Service Bulletin # 170

MODELS: DN100-5; DN145-5; DN204-6 and DN246-6

SUBJECT: Evaporator Fan Motor Brace.

FIG. 1

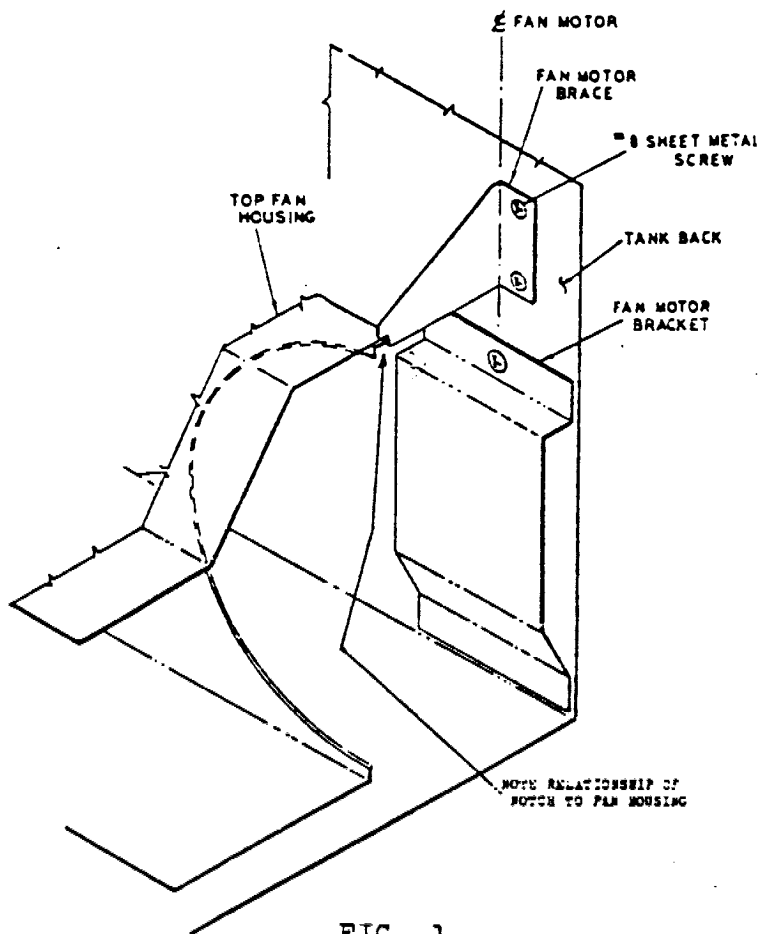
REASON: To provide a Brace to correct the problem of Fan Blade "Hang Up", if it should occur.

1. Remove the bottle/can chute.
2. Locate the fan motor Brace as shown, Fig. 1.
Caution: See C (Center Line) location of the Brace as related to fan motor and fan motor bracket.
3. Drill two (2) 1/8" holes (using Brace as a marking template), through tank back. Use 1/8" drill bit.
4. Secure the fan motor Brace with the two (2) Sheet Metal Screws provided.

ORDER AS: B/M164,012,100.04 Brace Kit for Fan Motor

KIT CONSISTS OF: 1 A164,010,140.03 Brace, Fan Motor
2 900,600,230.02 Sheet Metal Screw, #8 x 1/2"
